ADDENDUM NO.: THREE

REFERENCE:	IFB No:	2025-IFB-1007262
	Dated:	October 8, 2024
	Commodity:	New Construction High School Center II
	IFB Closing On:	November 7, 2024, at 2 PM

ADDENDUM 03

PROJECT: New Construction High School Center II
Albemarle County Public Schools
IFB #2025-IFB-1007262
QE Project No: 41911390

C5.0

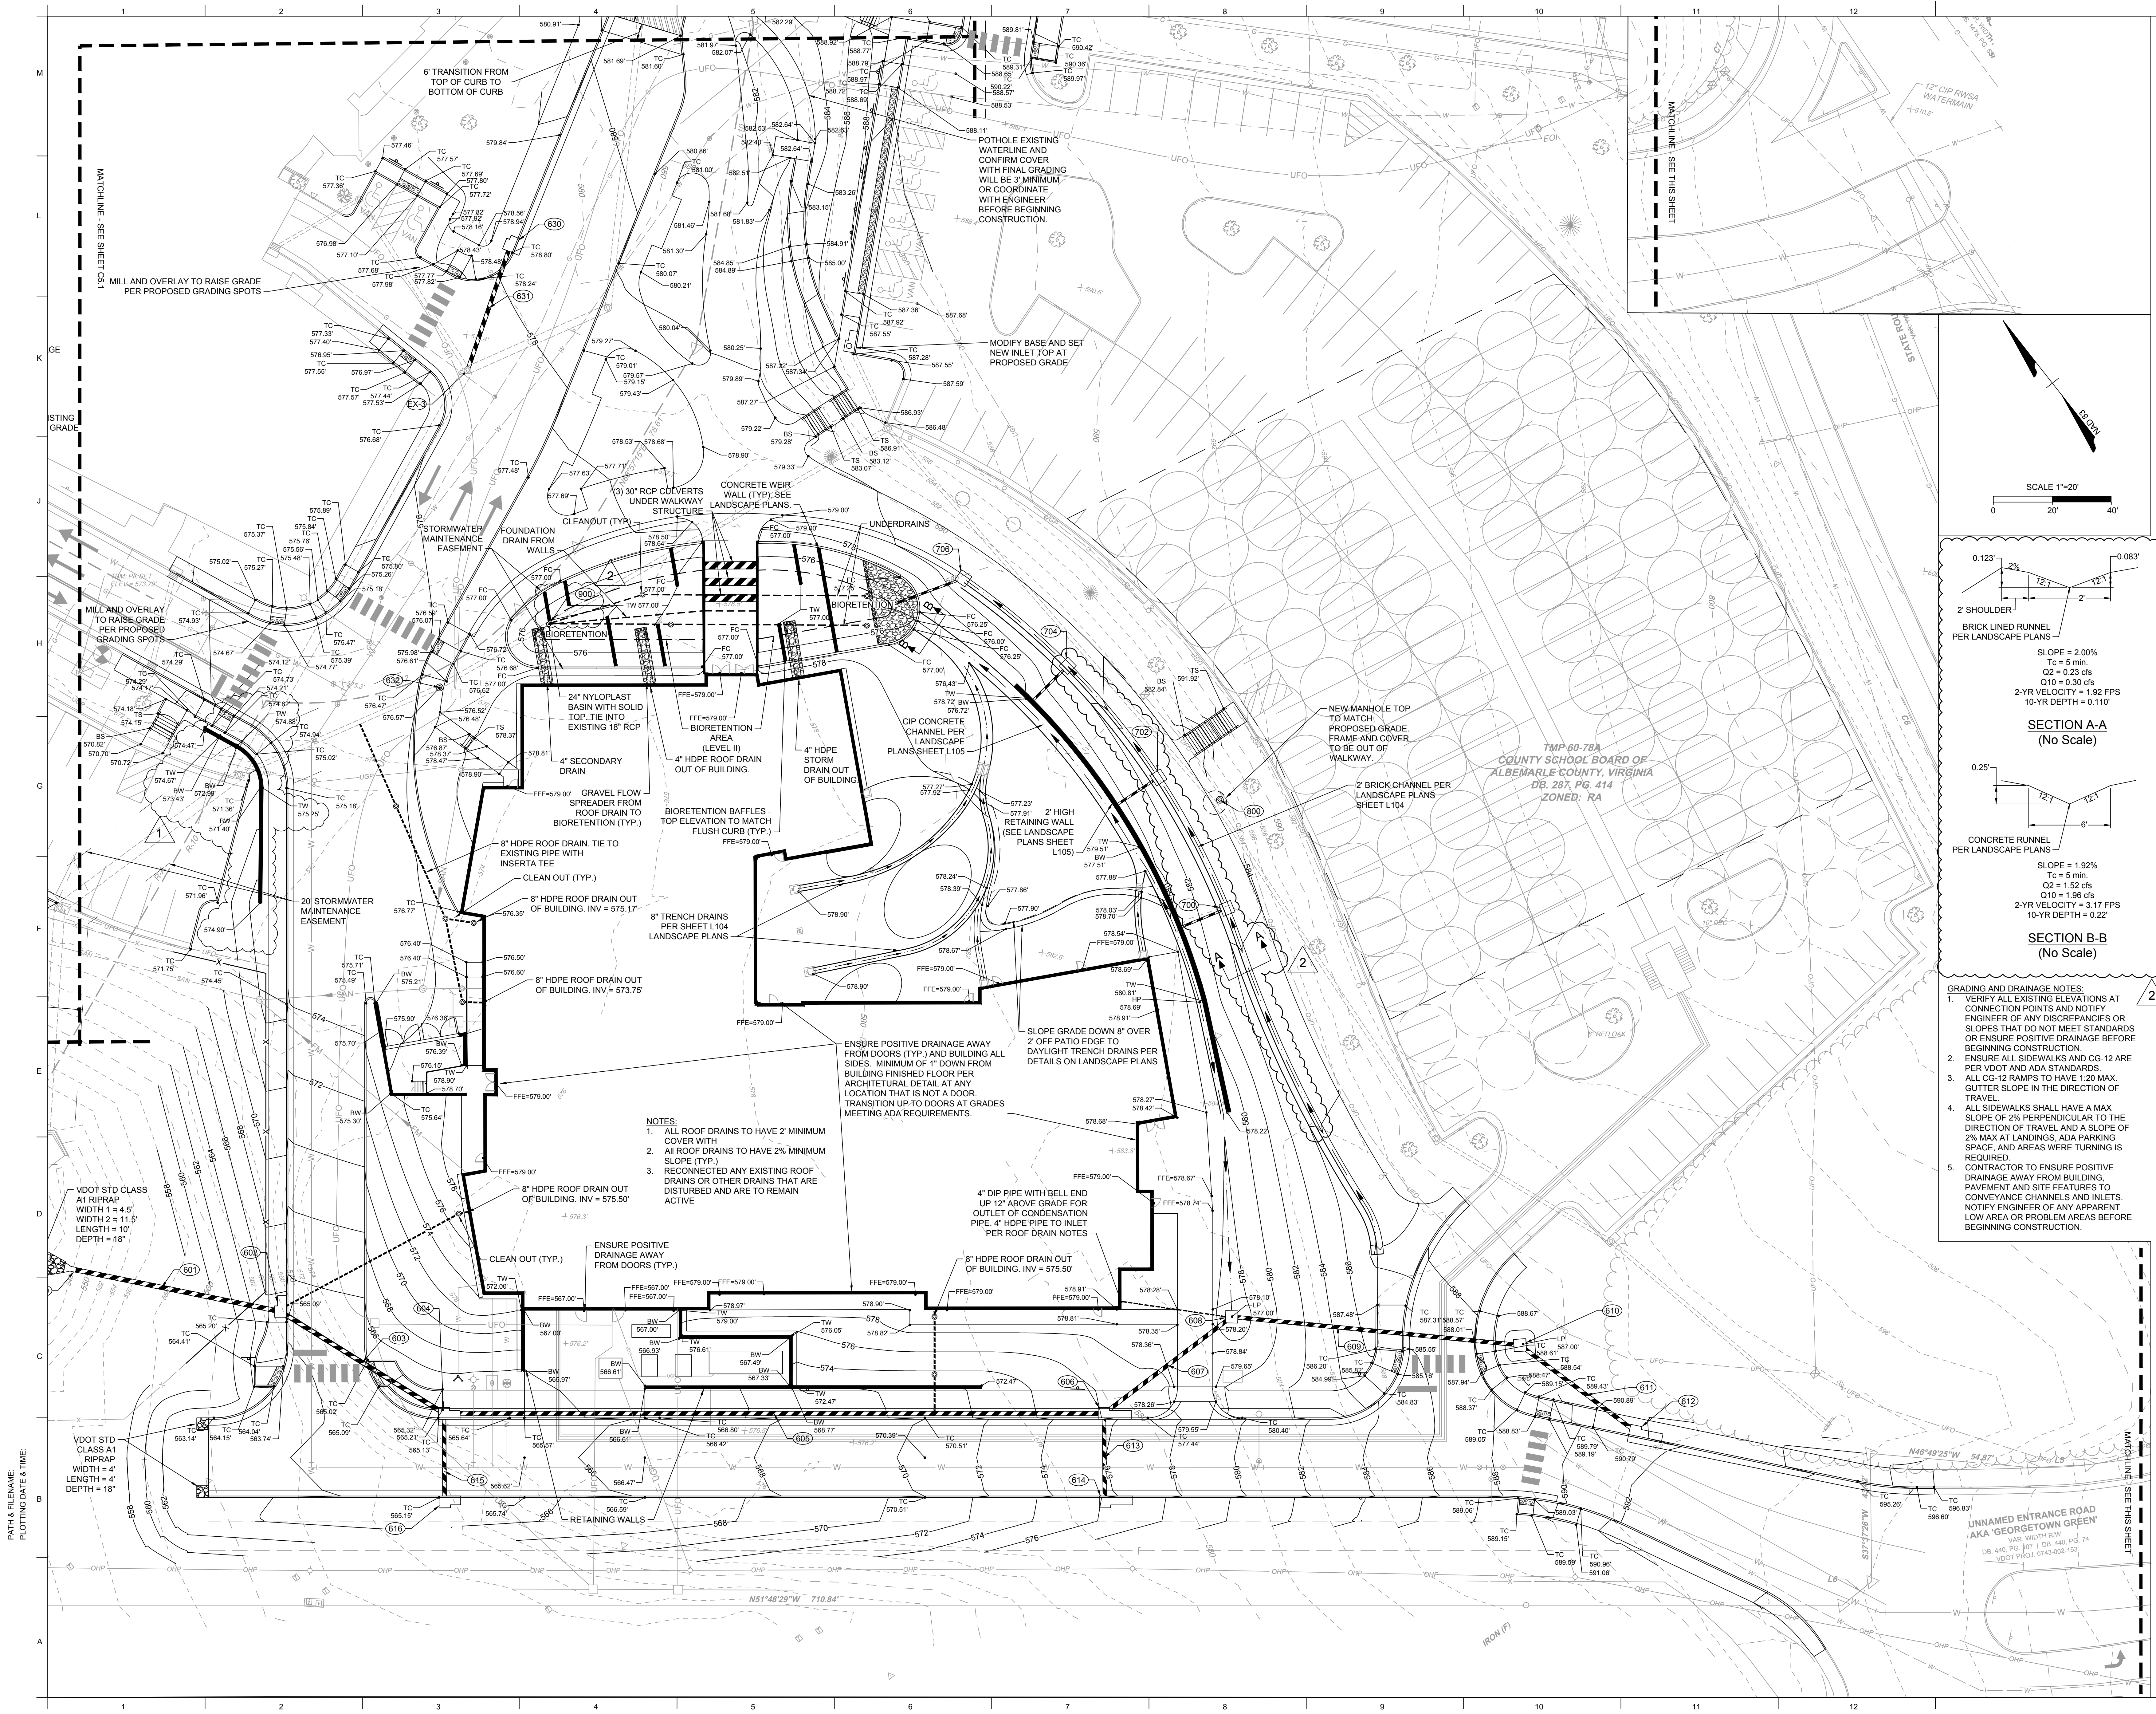
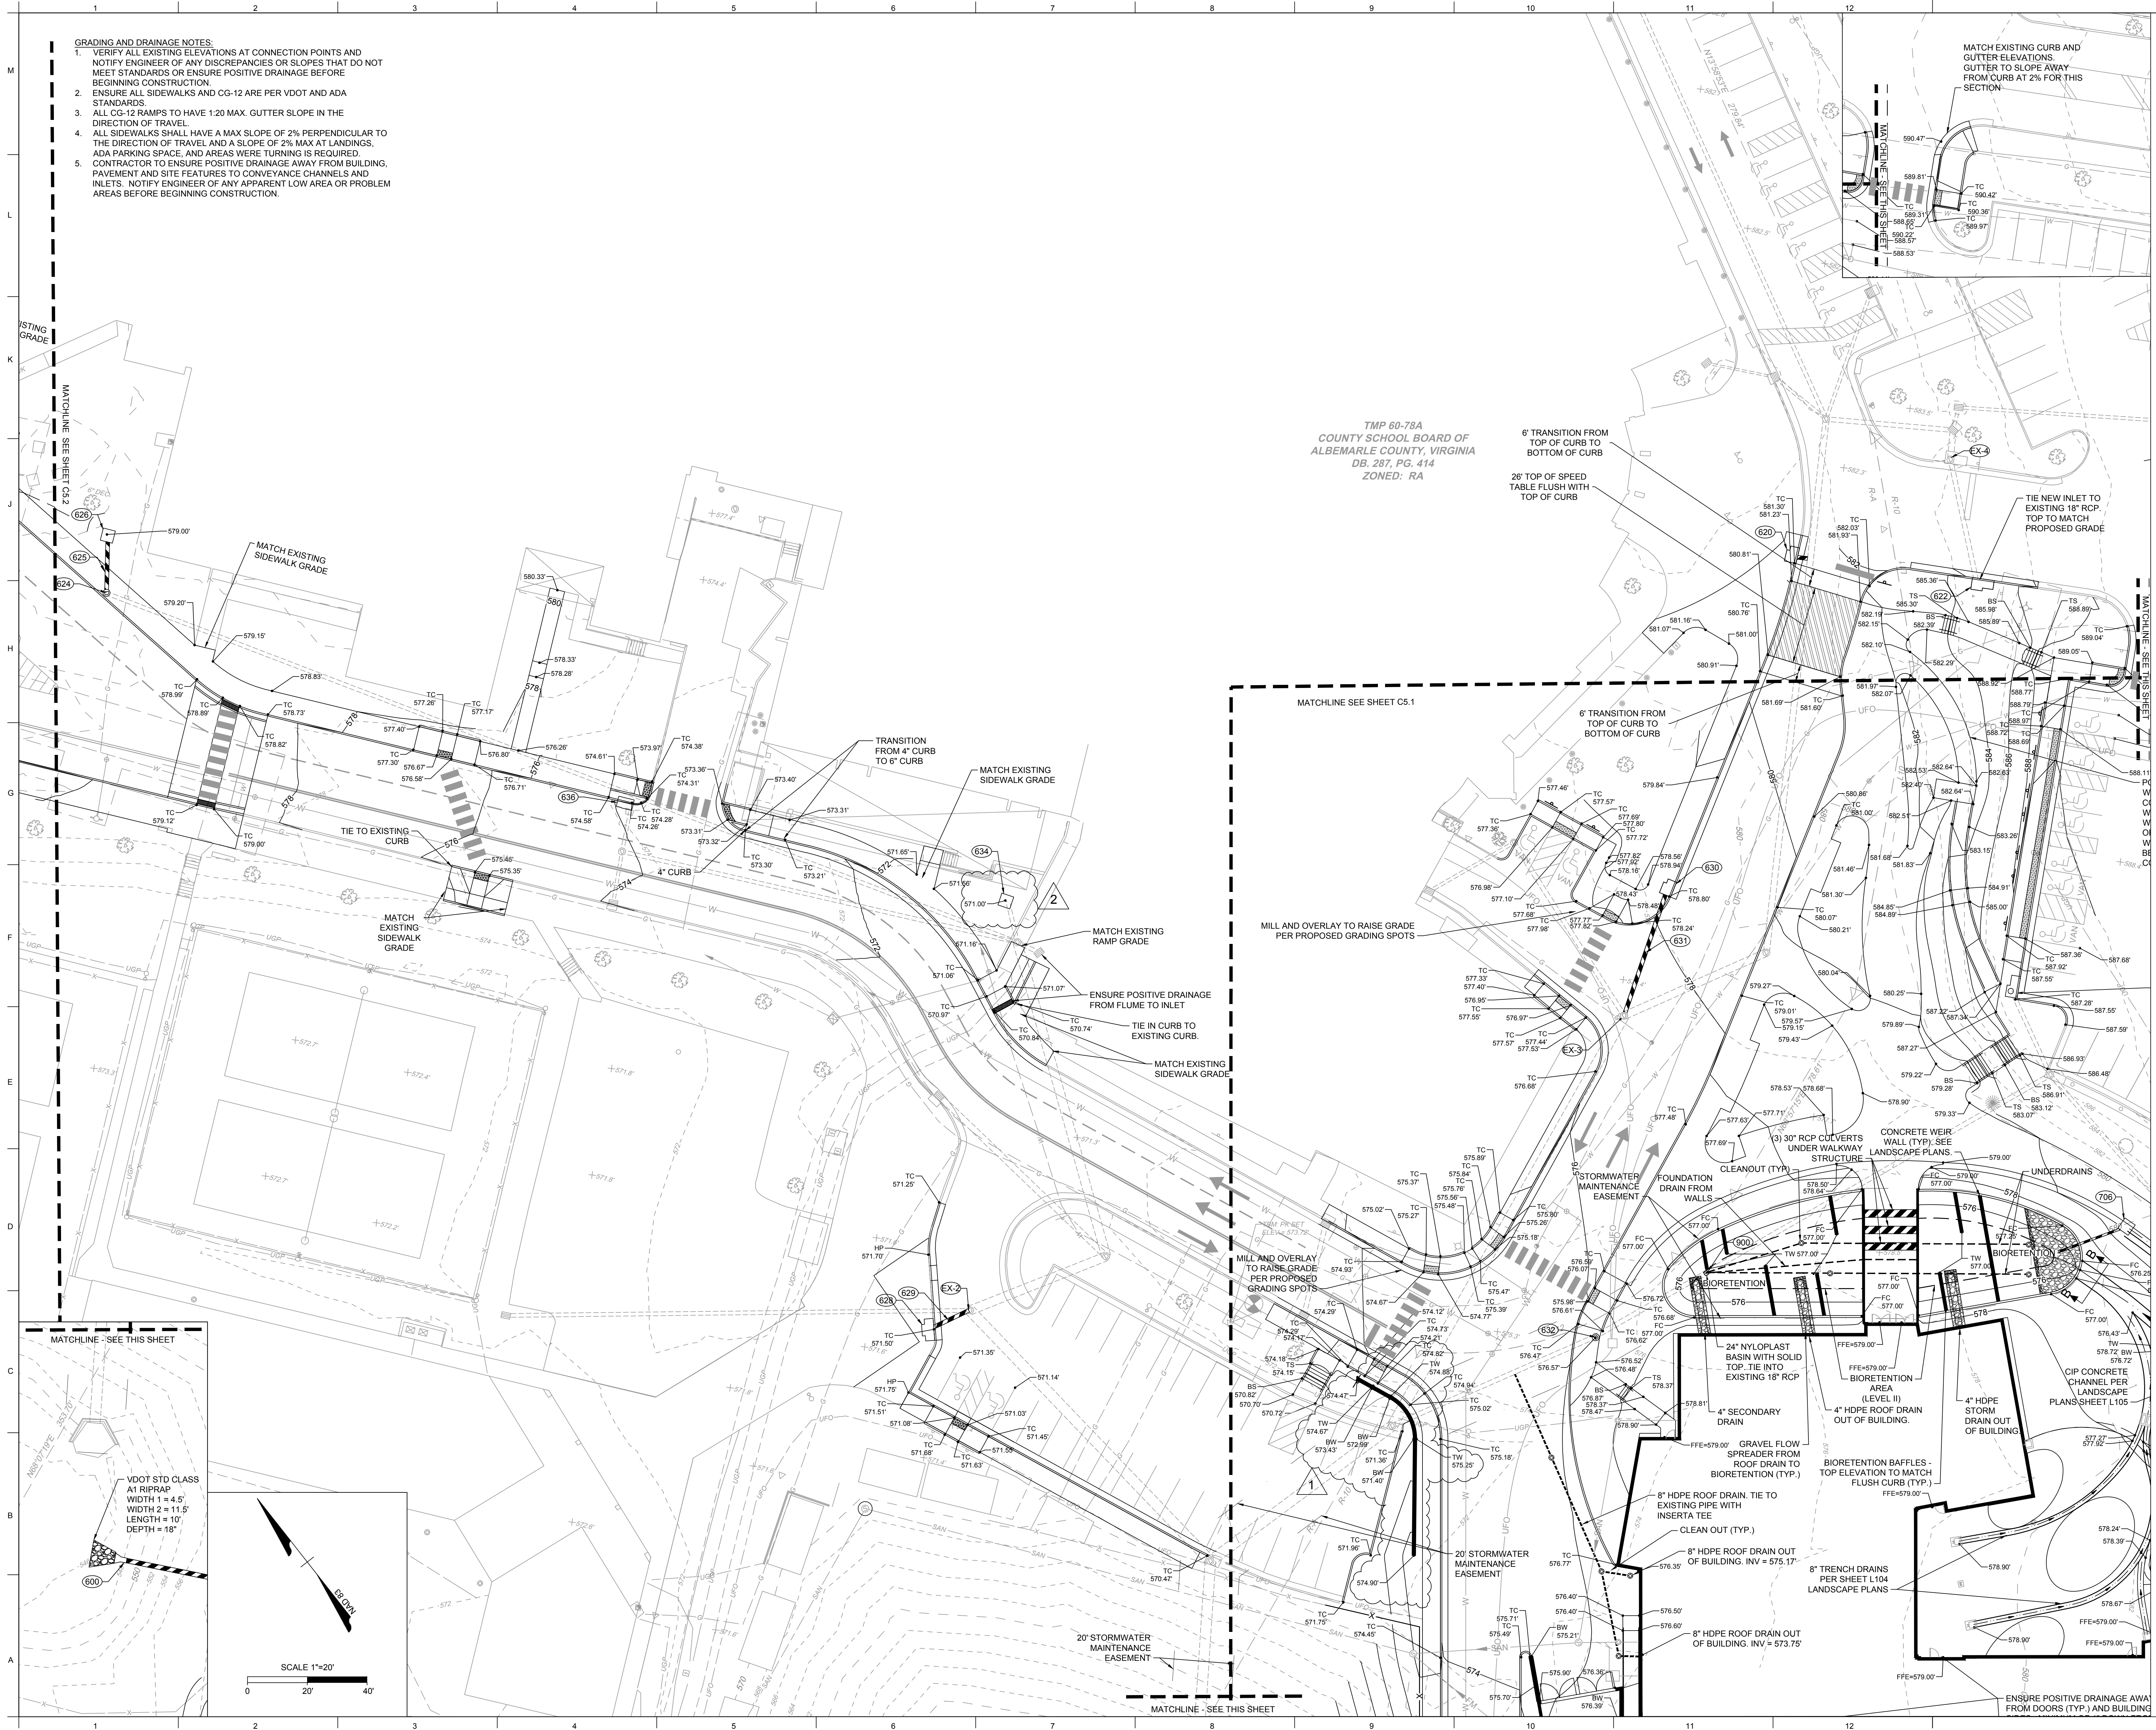
Sheet: C5.0 – Grading and Drainage Plan
Replace: With revised Sheet included herein
Changes: Updated ditch sections and shoulder grading to match landscape details and ditch calculations. Some labels added or clarified.
